ADDENDUM NO. 2

March 1, 2022

**TIMOTHY BALL ELEMENTARY SCHOOL ADDITIONS, RENOVATIONS,
AND RELATED WORK
Crown Point, IN 46307**

This Addendum forms a part of and modifies the Bidding Requirements, Contract Forms, Contract Conditions, the Specifications, and the Drawings dated February 7, 2022 by Gibraltar Design. Acknowledge receipt of the Addendum in the space provided on the Bid Form. Failure to do so may subject the Bidder to disqualification.

© GIBRALTAR DESIGN SHEET
B MP106

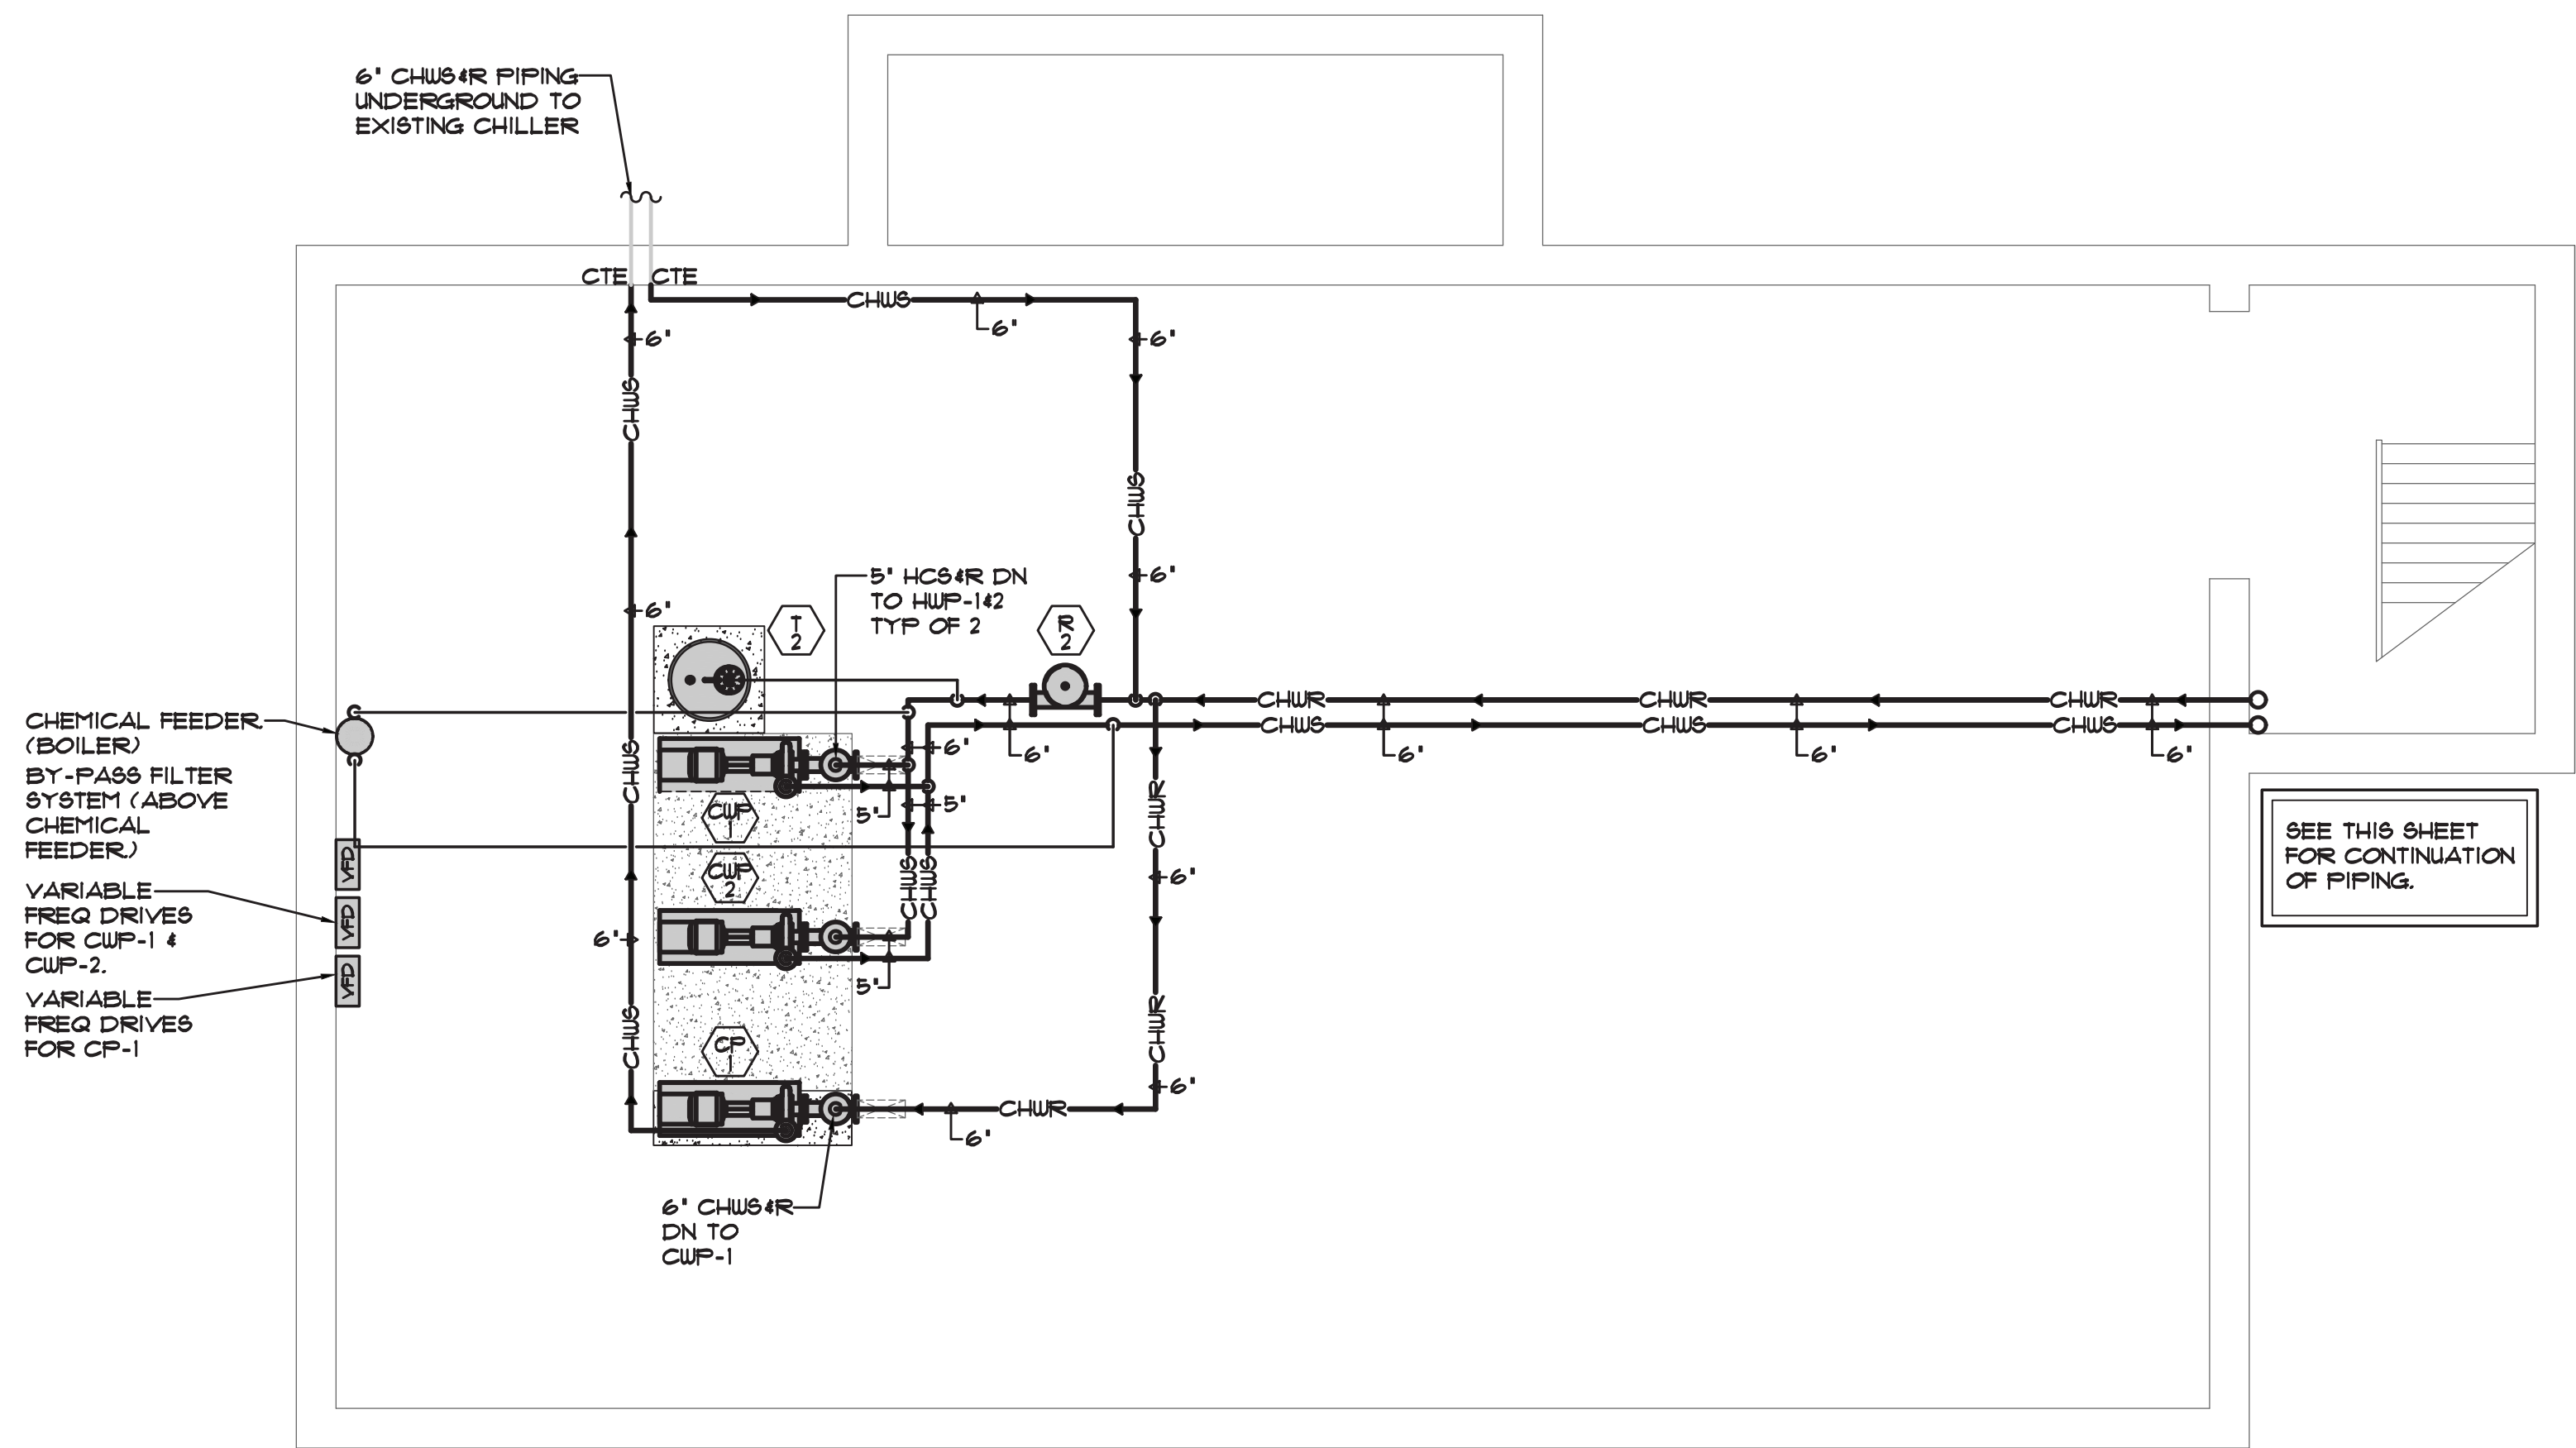
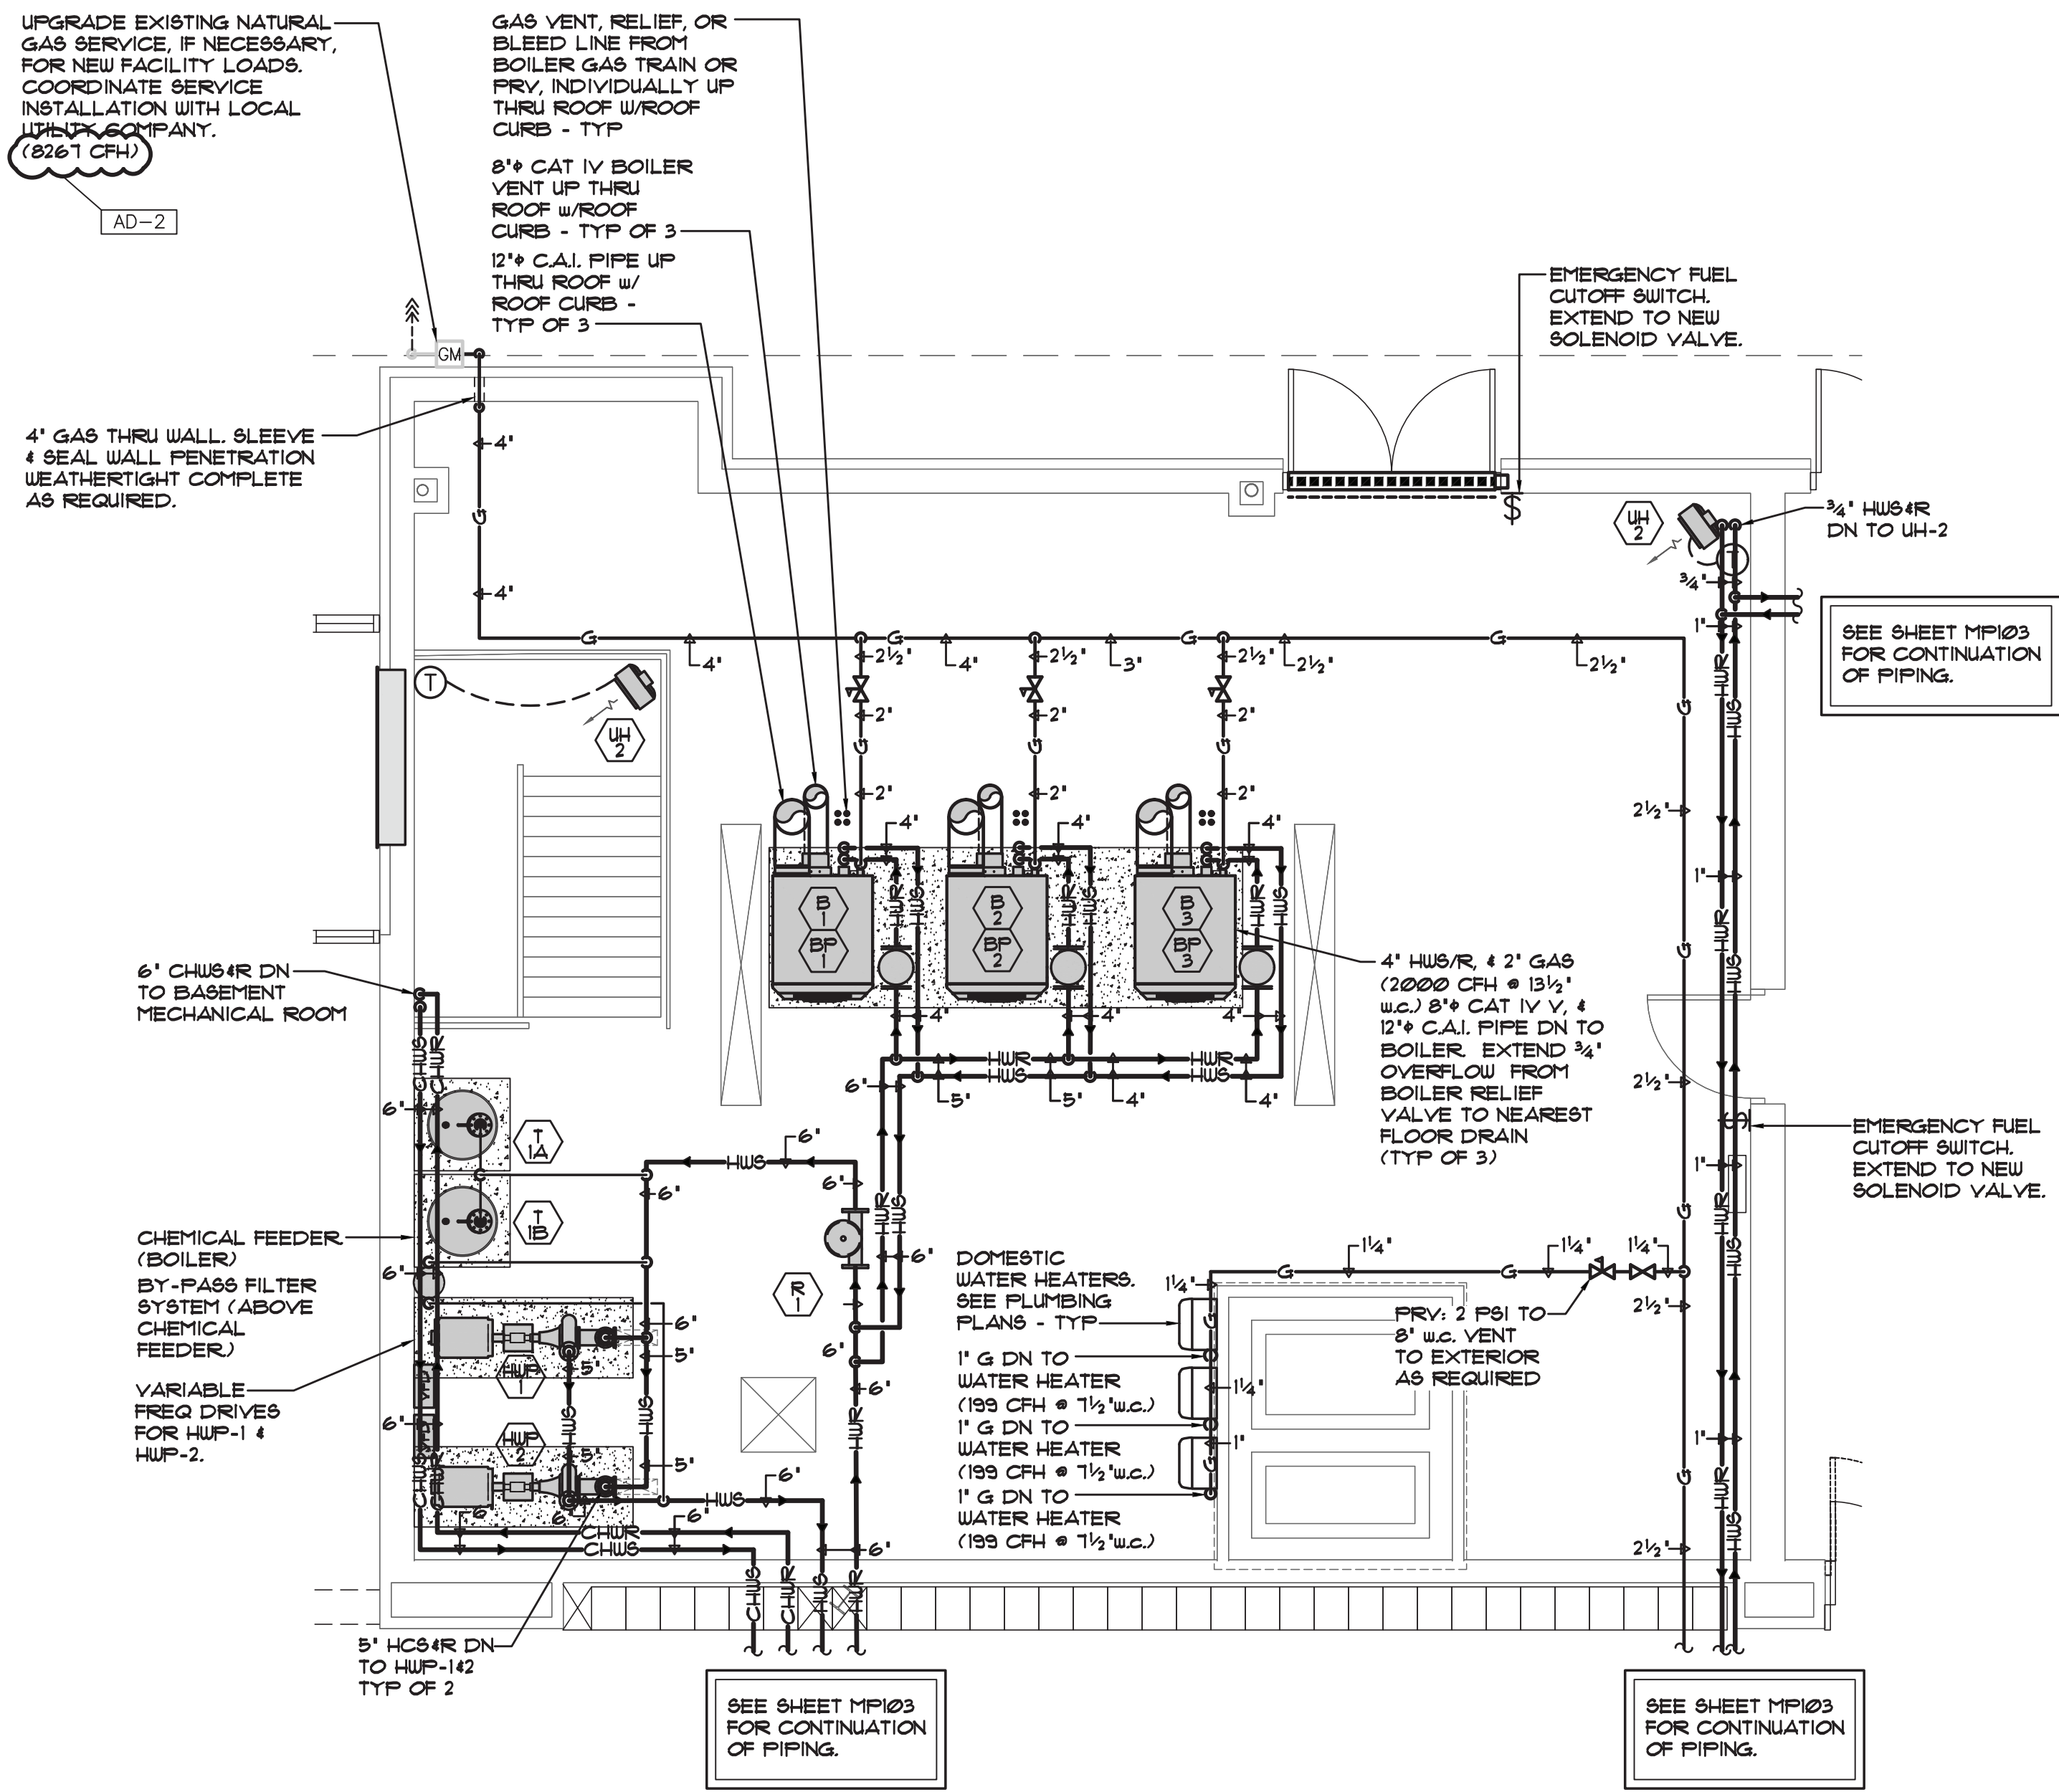
30. Sheet MP106

- A. Refer to revised, full size drawing, included in this Addendum, for the following revisions:
1. Revised total additional gas load.

© GIBALTAR DESIGN SHEET
M-201

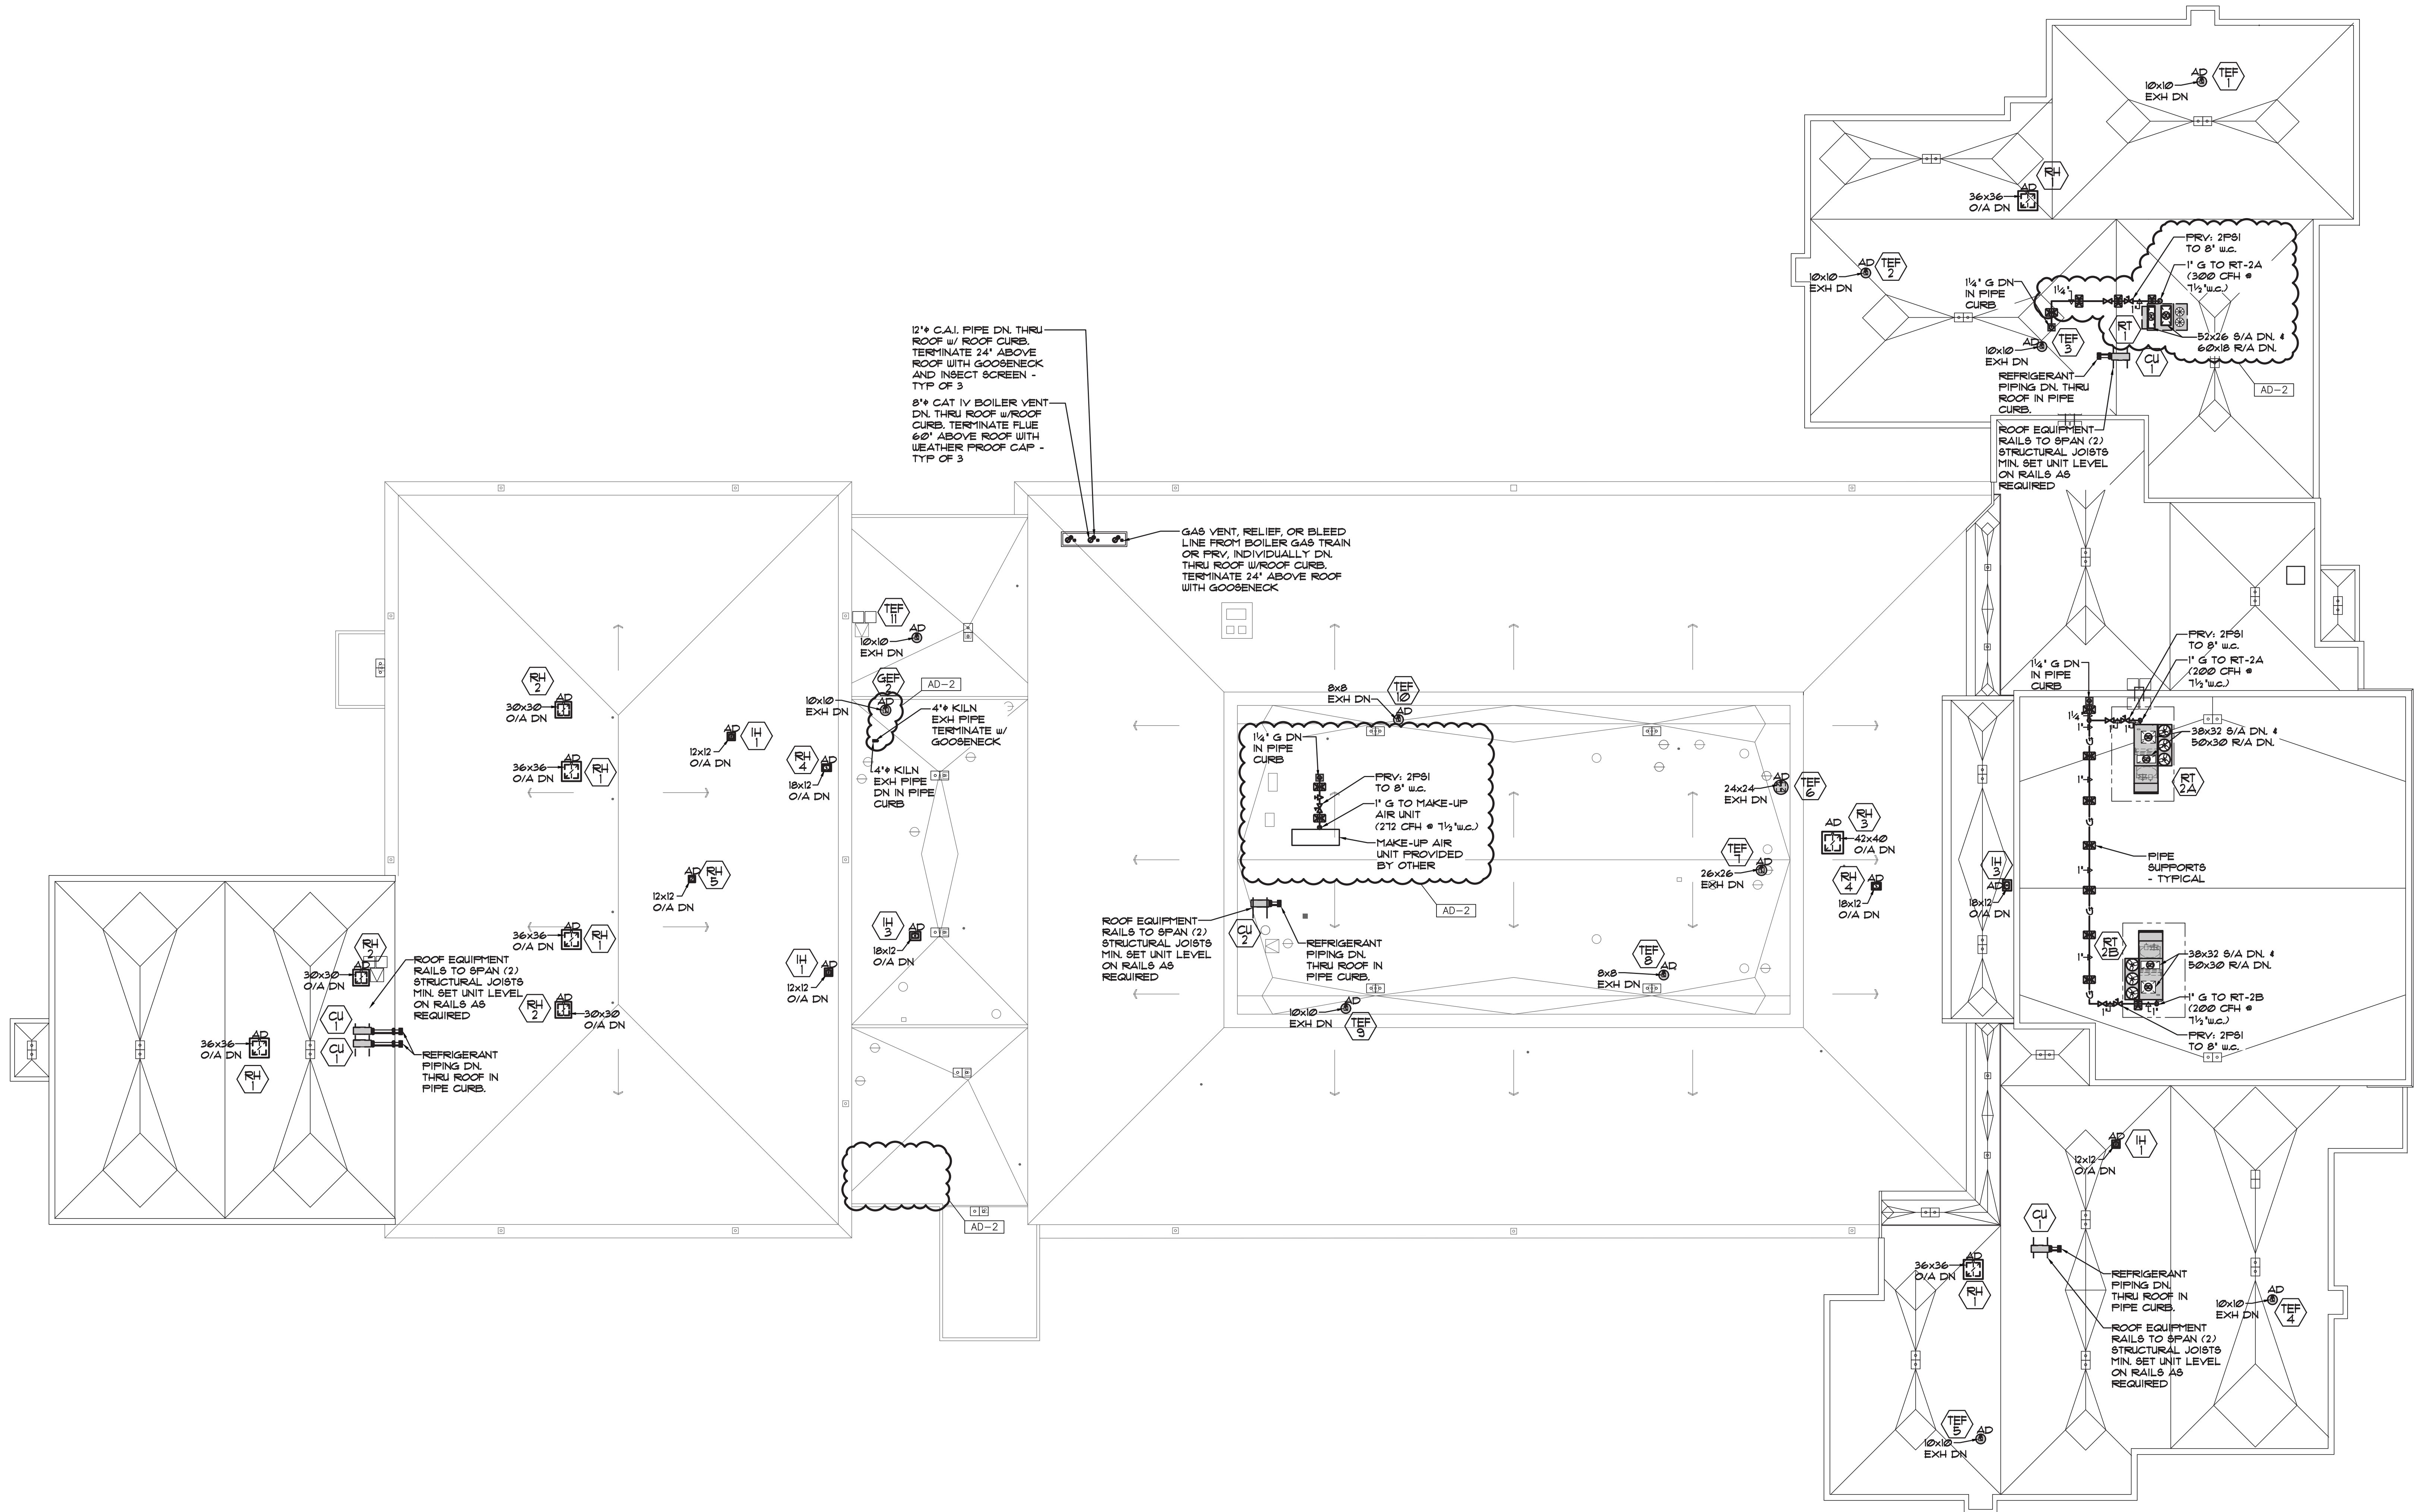
31. Sheet M-201

- A. Refer to revised, full size drawing, included in this Addendum, for the following revisions:
1. Removed intake hood.
 2. Revised location of kiln exhaust and general exhaust.
 3. Added gas to make-up air unit.
 4. Revised location of RT-1.
